HOPE CREEK GENERATING STATION
ENVIRONMENTAL REPORT-OPERATING LICENSE STAGE
AMENDMENT 2 PAGE CHANGES

The attached pages, tables, and figures are part of your controlled copy of the Hope Creek Generating Station ER-OLS. This material should be incorporated into your ER-OLS by following instructions below.

Amendment 2

TABLE 3.3-1

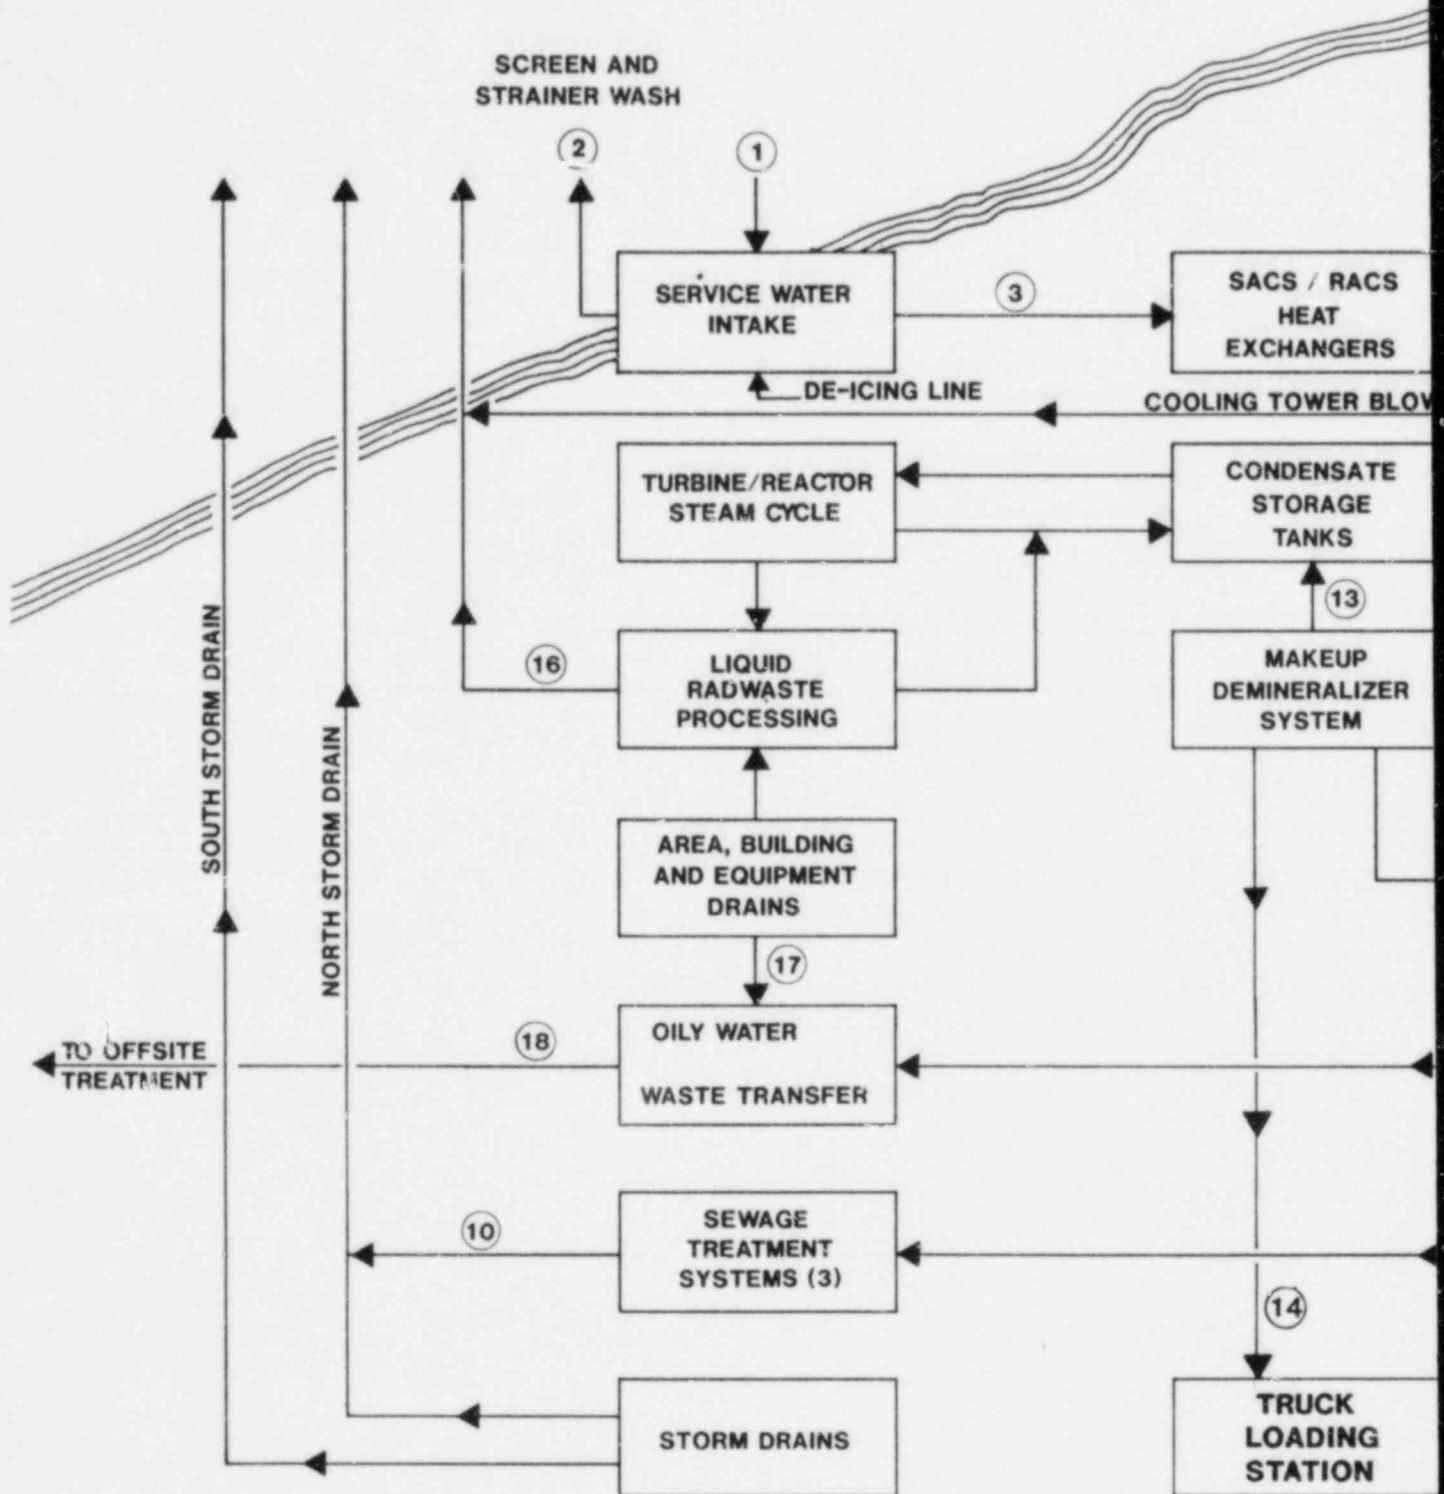
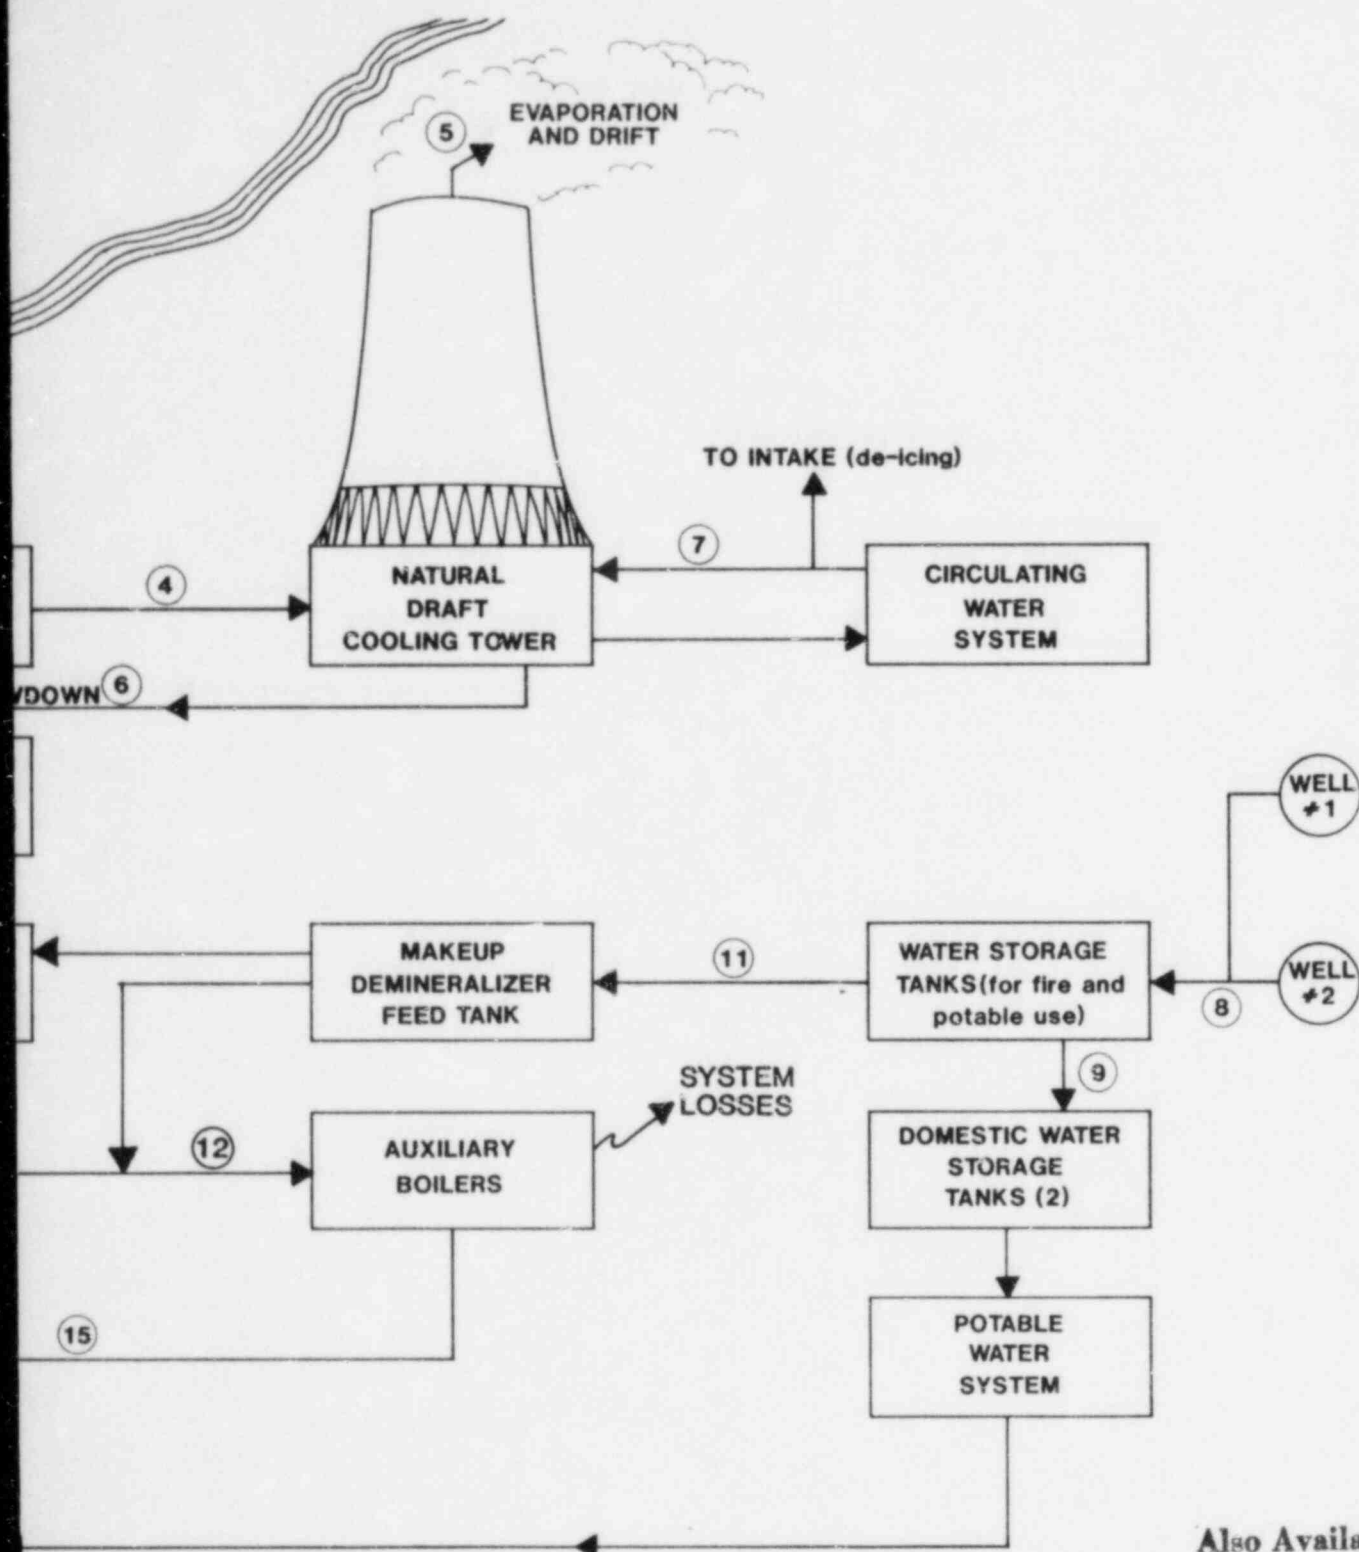
E291.6

Use this table in connection with Figure 3.3-1.

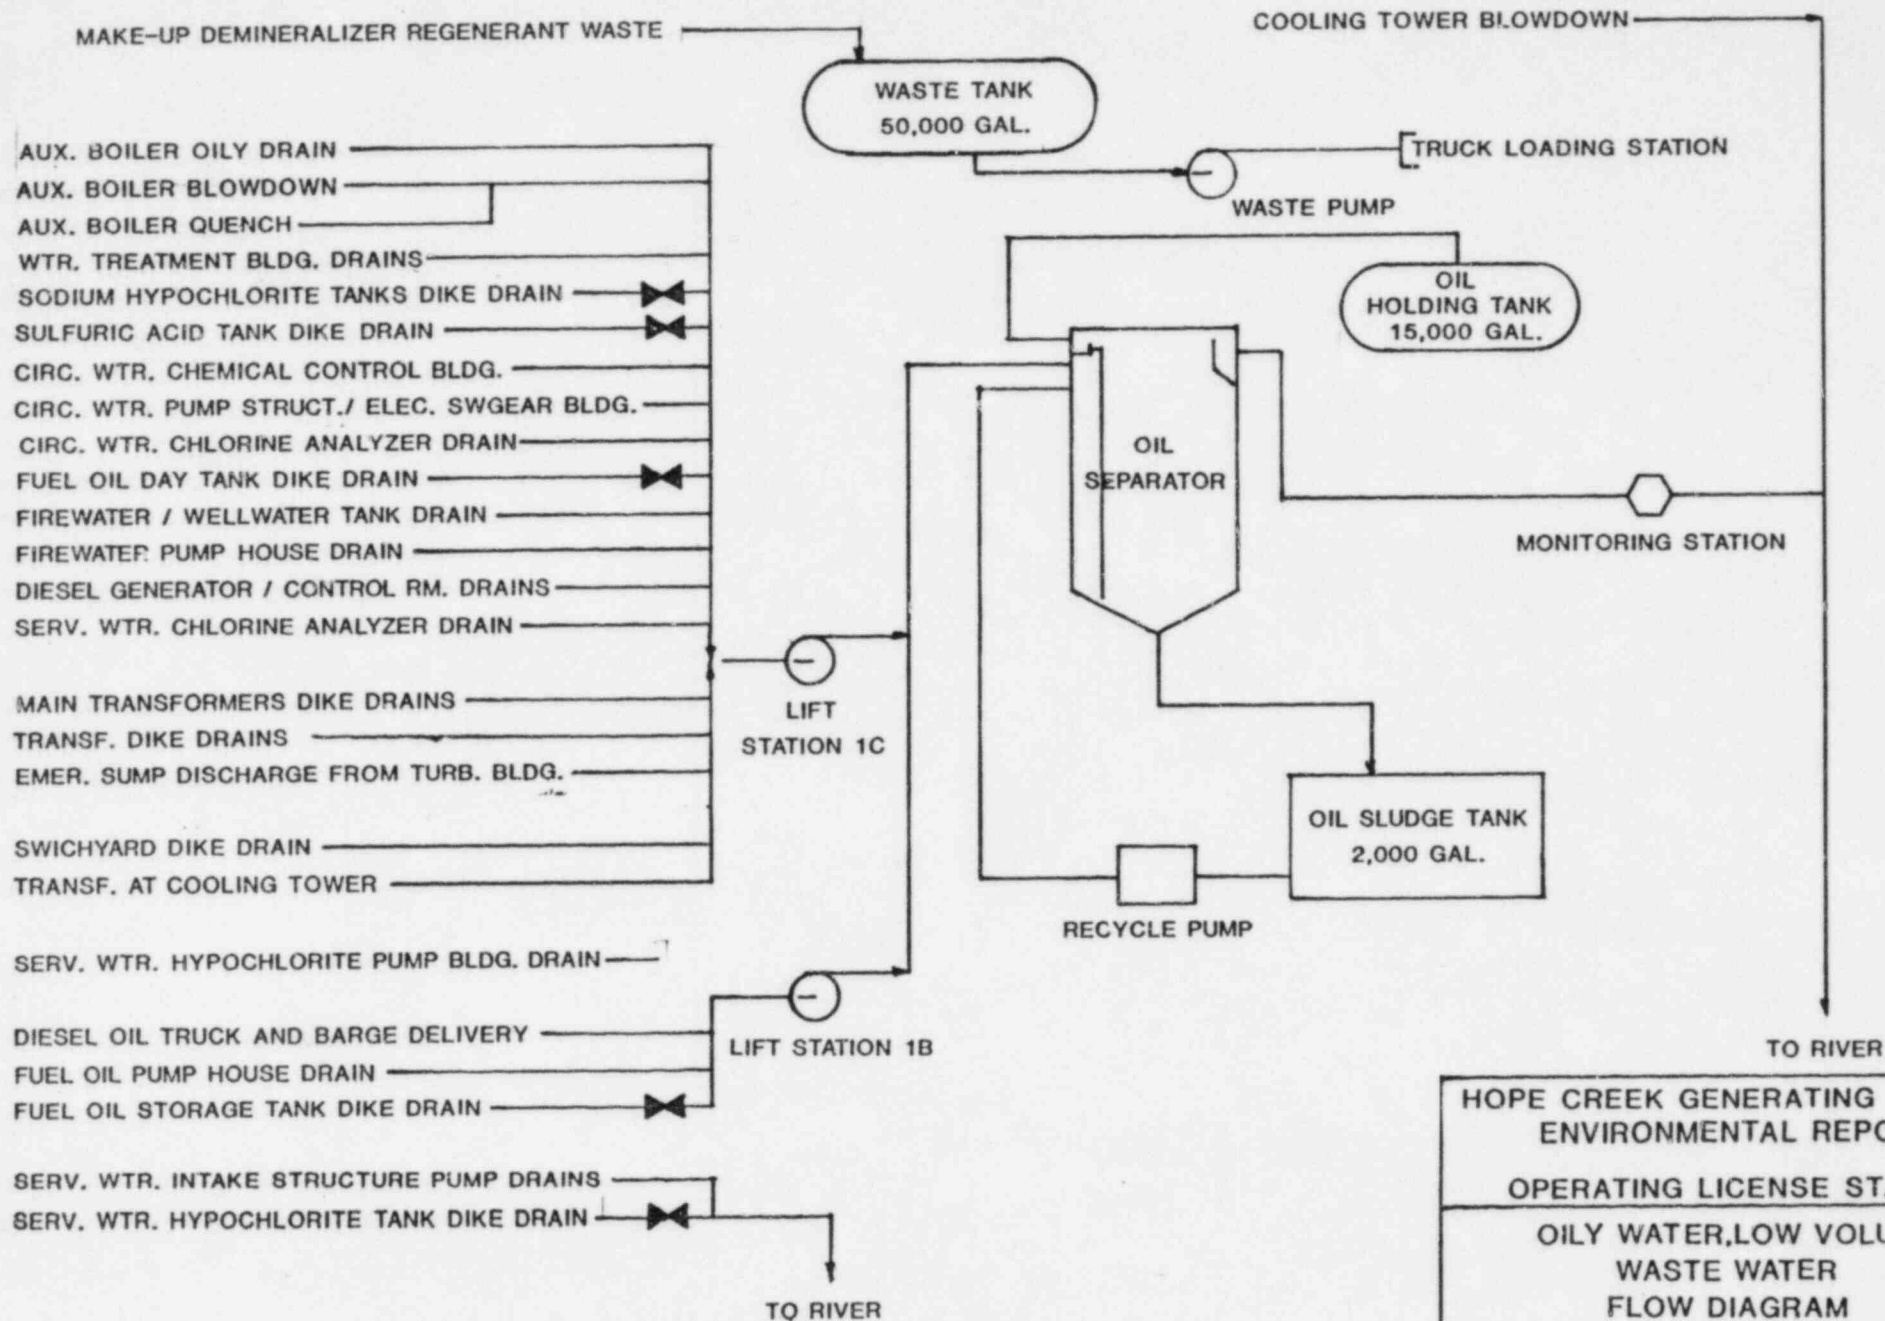
QUESTION E291.21 (Section 5.1)

The cooling tower blowdown discharge location has been changed since the CP stage FES from 200 feet offshore to 10 feet offshore (essentially shoreline) in the river. Provide a comparative discussion of the impacts to the river biota (from thermal and chemical effluents) due to this relocation.

Chemical discharges associated with cooling tower operation are also present in cooling tower blowdown. Sodium hypochlorite to control biofouling and sulfuric acid to control scale buildup are among the chemicals present. The biocide methodology for HCGS at the OL stage is currently under study (see Questions E291.16 and E291.19). For now it can be said that chemical use will be reduced due to the cancellation of Unit 2. Also any biocide such as chlorine and any other chemical such as sulfuric acid which will be discharged in the cooling tower blowdown will meet applicable effluent limitations and be diluted to a low level at a short distance from the end of the pipe due to the rapid mixing of the discharge with river water. It is expected that the concentrations of all chemicals found in the blowdown will be small and will not harm any organisms that may be present.
